Our ref: L.A11230.003.StPhilipsCC-RTS.docx

RE: RESPONSE TO SUBMISSION - ST PHILIP'S CHRISTIAN COLLEGE, CESSNOCK SSDA

Table 1.1 Response to Submission

Figure 1.1 1% AEP Flood Inundation Duration in Lomas Lane

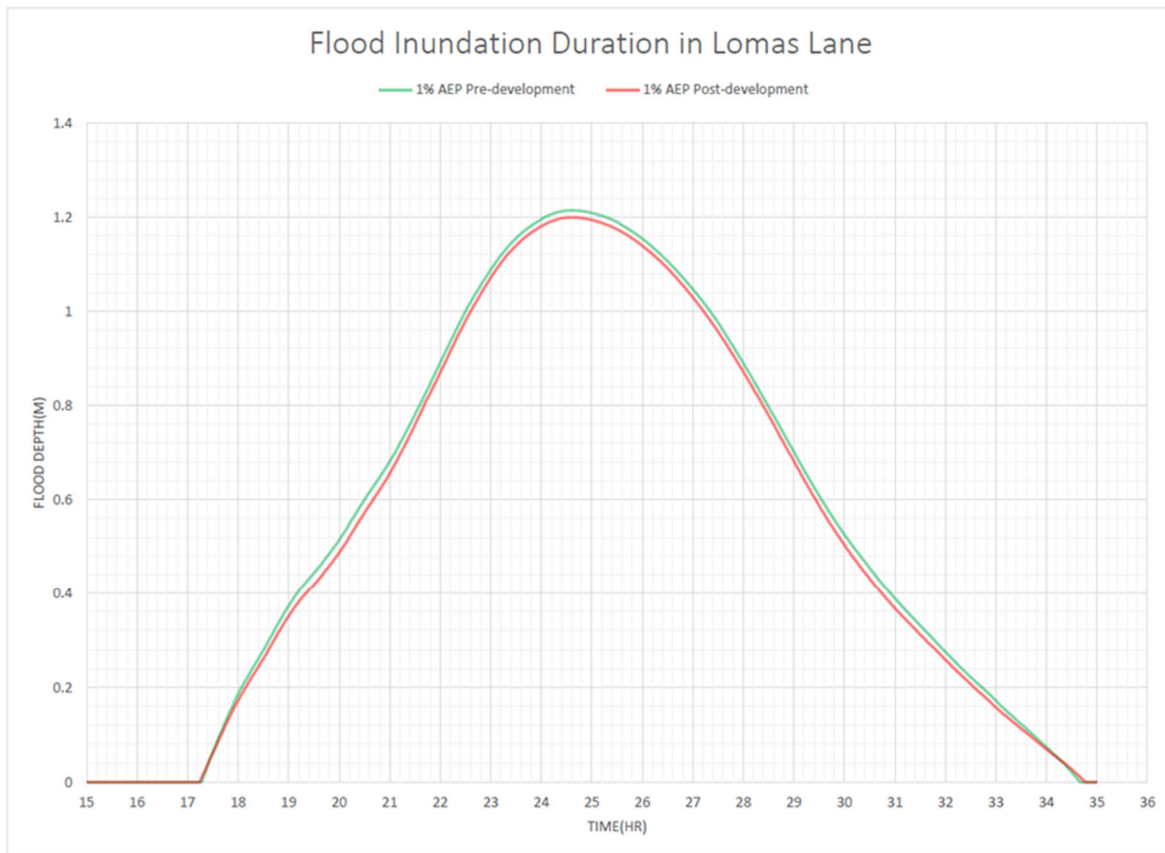
3.3 Explanation <i>The EIS does not adequately consider the requirements of the Water Management Act 2000. Section 4.11.2 of the EIS notes that as a SSD, the project is exempt from approval under that Act. However, the development is not exempt from being consistent with the Act and must address the requirements in the SEARs which includes surface water and watercourse impacts.</i> <i>The EIS has considered off-site flood impacts, but not potential geomorphic impacts arising from increased flood flow velocities. With 24,500 cubic metres of fill into the site, the floodplain for Black Creek will in effect be constricted by the new building footprints. The effects of such constrained flow during peak flood events has not been explored. The proponent should, with reference to the NSW River Styles Database, consider the likely geomorphic impacts of the project on downstream environments, most notably the broad bridge crossing</i>	Based the NSW River Styles Database, Black Creek has fine grained bed. To assess the potential geomorphic impacts of the proposed development, the following hydraulic indicators have been assessed. • Peak Flow Impact: Table 1.3 presents the predicted peak flows for the pre-development and post-development scenarios downstream of the site for the 38%, 2% and 1% AEP events. The results indicate that the proposed development will not result in an increase in peak flow in Black Creek downstream of the site. • Velocity Impact: Figures E-1 to E-3 show predicted peak velocity impacts downstream of the site for the 38%, 2% and 1% AEP events. These demonstrate that the proposed development will not result in an increase in peak velocity in Black Creek downstream of the site. • Bed Shear Stress Impact: Figures E-4 to E-6 show predicted peak bed shear stress impacts downstream of the site for the 38%, 2% and 1% AEP events. These demonstrate that the proposed development will not result in

Agencies Submission	BMT Response
<i>Black Creek on Lomas Lane. Mitigation options to prevent incision, erosion and infrastructure damage may need to be explored.</i>	an increase in peak bed shear stress in Black Creek downstream of the site. Given the above results, the proposed development is not anticipated to increase scour potential and hence unlikely to cause geomorphic impacts in the creek.
<u>Biodiversity and Conservation Division (BCD)</u>	
<i>4. BCD advises that the proponent should provide further information as to the flood risk, including any changes to the timing of the inundation of Lomas Ln and any accessways to properties from that road.</i>	The afflux maps provided show there's minimal peak flood level impact on Lomas Lane. The timing of inundation of Lomas Lane has not changed as a result of the development. Figure 1.1 shows the inundation duration in Lomas Lane at the adjacent to the eastern access to the school.

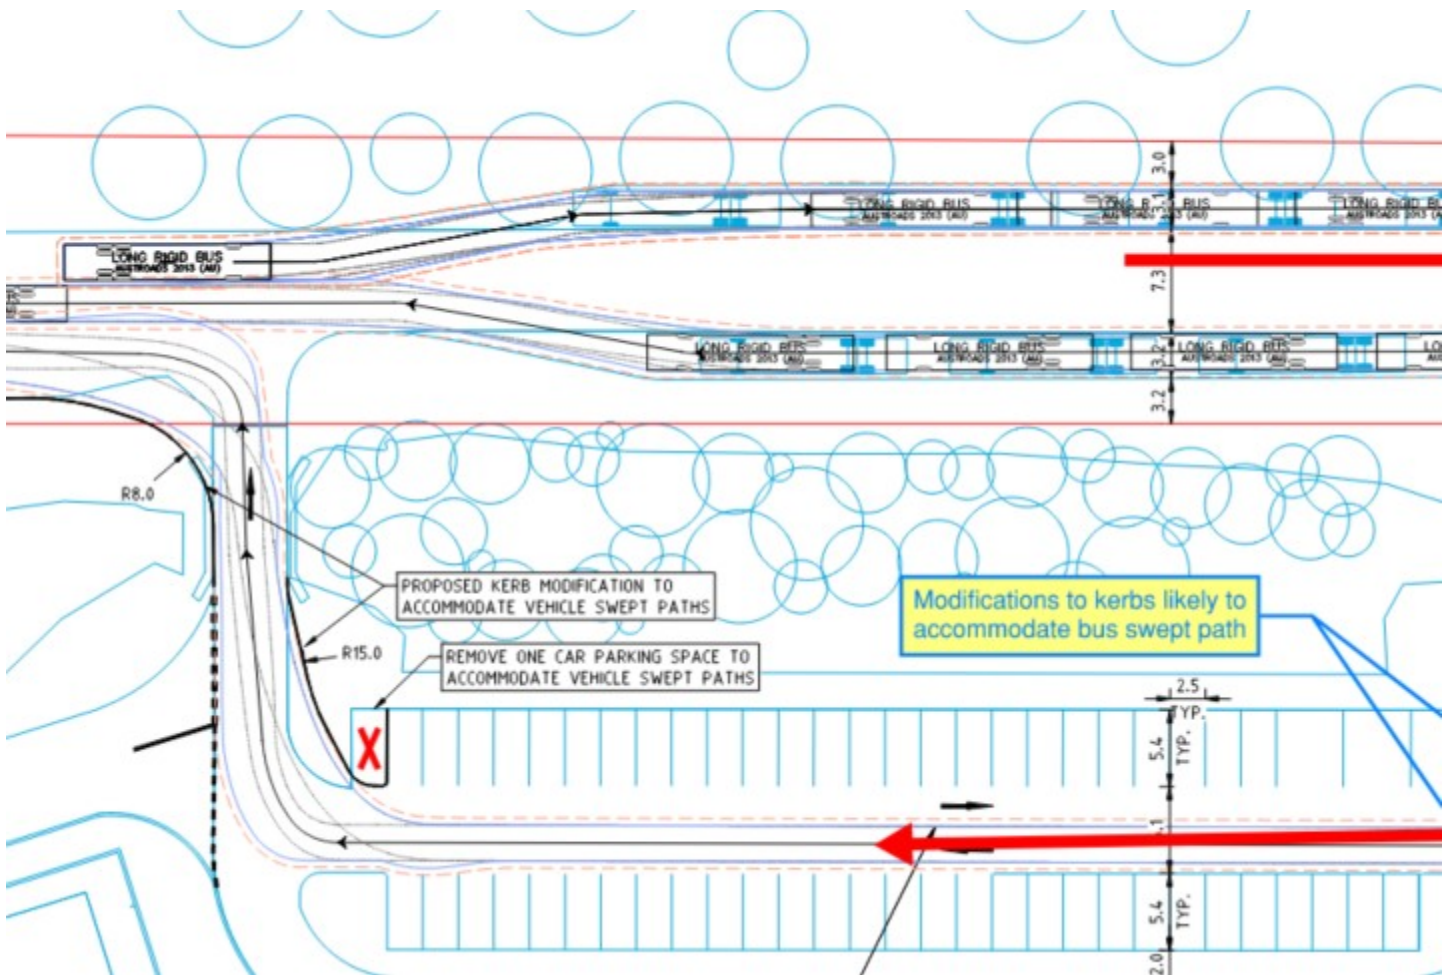
- Minor modifications will be required for the central access to allow buses to turn around, with the bus loop to the east anticipated to be flooded.
 - Subject to swept paths, kerbs to be amended and may potentially result in the loss of one parking space and the marked crossing would likely need to be extended – refer below bus route in red.

B-8

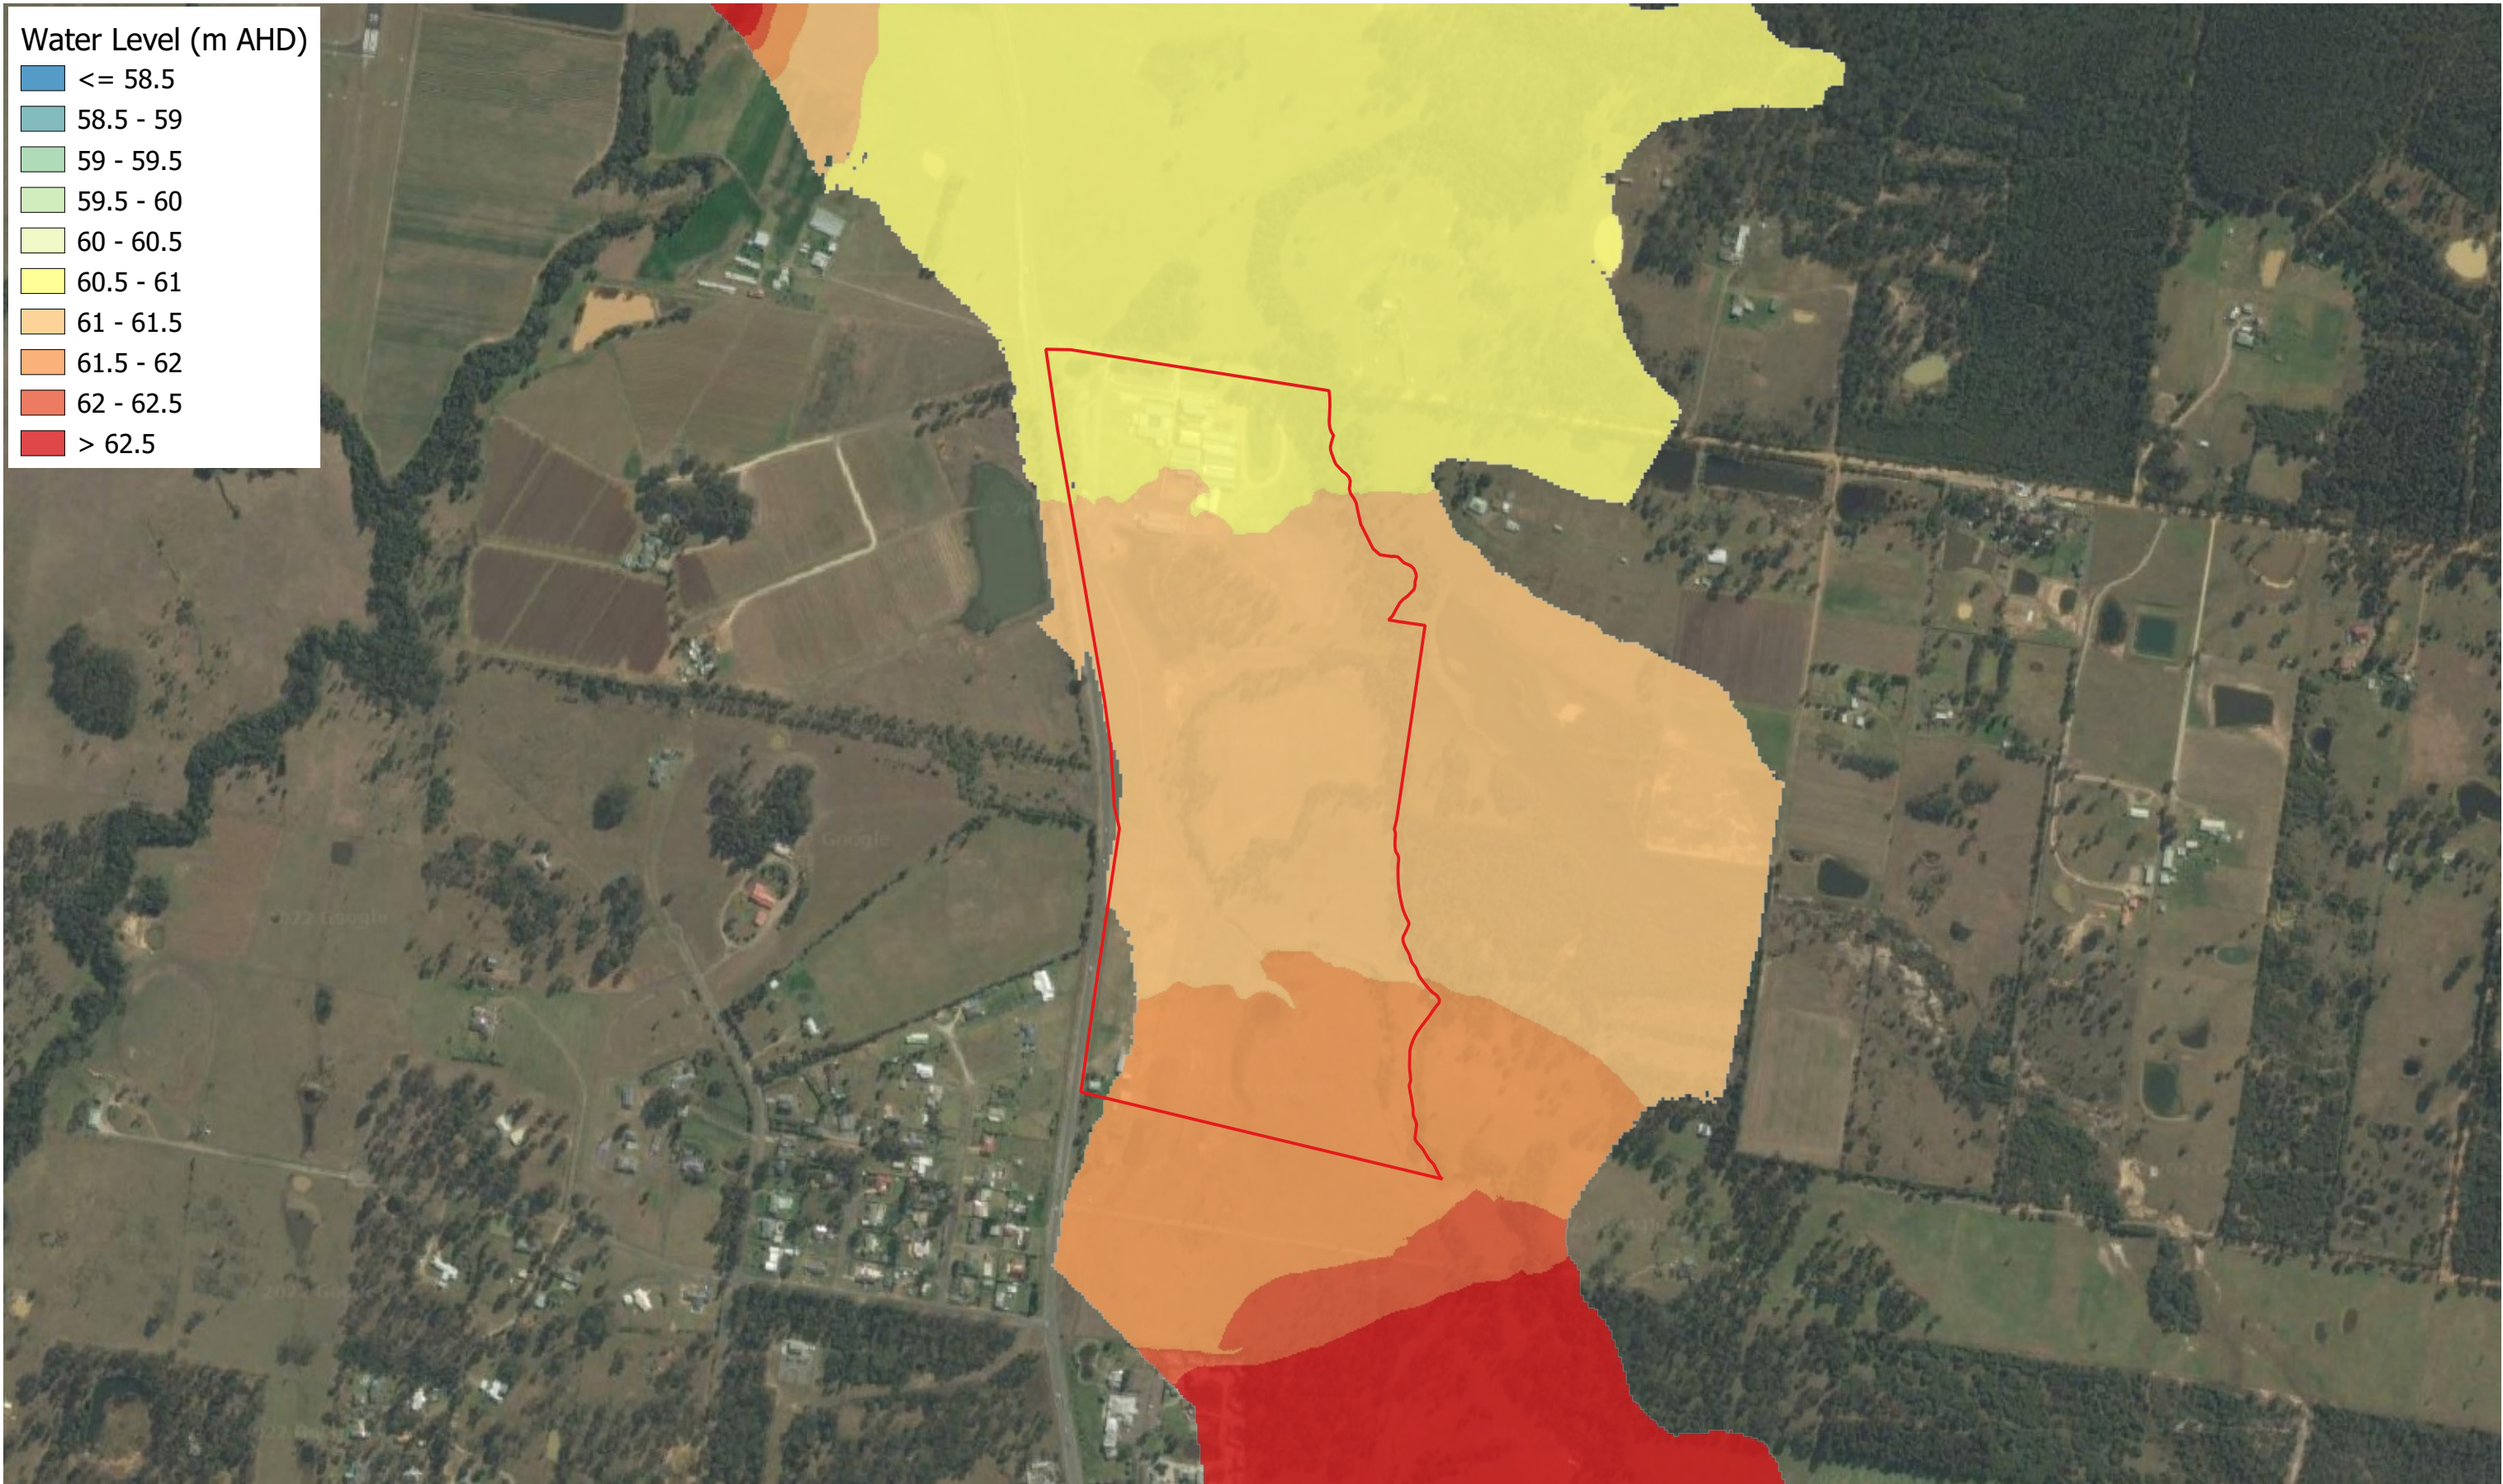
<i>• the Department requests that the existing arrangements for evacuating school students be analysed and the future evacuation methods be provided in detail and compared to the existing evacuation methods. It should be noted that the school students will not be able to self-evacuate. Consequently, the FERP must include analysis of scenarios where parents would arrive to pick up children prior to a flood event impacting access routes to the site and what impact that would have on the surrounding roads.</i>	BMT has prepared an updated Flood Emergency Response Plan (FERP) for the Site which assessed feasible evacuation routes and recommended early evacuation as the primary flood emergency response strategy. Detailed arrangements for the full evacuation of the Site are included in the updated FERP. Also attached herein is the Traffic Engineer's commentary on the feasibility of the FERP.
<i>• Council's submission raised concern that the Council's mapping of flood prone land differs to that shown in the submitted FIA. The Department requires you to address Council's concerns as part of a revised FIA, including the following matters:</i> <i>○ no structures are permitted within the floodway.</i> <i>○ on-site refuge during flood events is not supported.</i> <i>○ flood free access is not demonstrated for a 1% AEP.</i> <i>○ flood water is shown to increase by 20-50mm along the eastern boundary of Lot 892 DP 574957.</i>	As per previous responses for Cessnock City Council
